BMW Group
Dealer: 32711/06
Model: M2
Development code: G87
Model code: 13DM
Lead type: 13DM

Service Information Bulletin

RECALL 23V-039: SIDE AIR BAG COVER (REAR SEATS)

B52 01 23 [SI] February 2023

RB52 01863

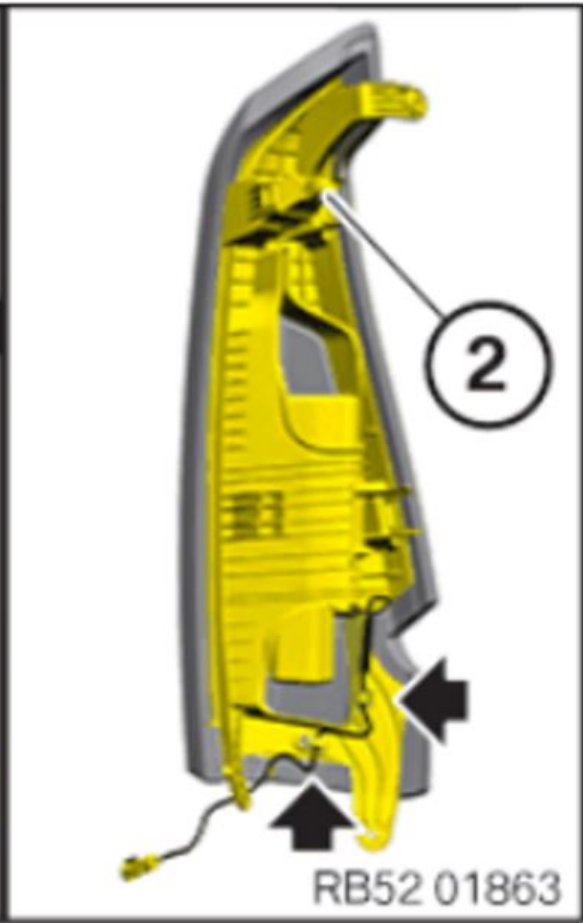
Replace both rear seat backrest side panels which contain the air bag.

Replace the rear seat backrest side panels (left and right; circled) in accordance with repair instructions
--	---

Unclip and
remove the
backrest
side panel
section (1)
on the rear
seat
backrest
from the
clamp (2).

Check the
clamp (2)
for damage.
A
replacement
clamp
should be
present on
the new
part.

Repeat for
opposite
side of
vehicle.
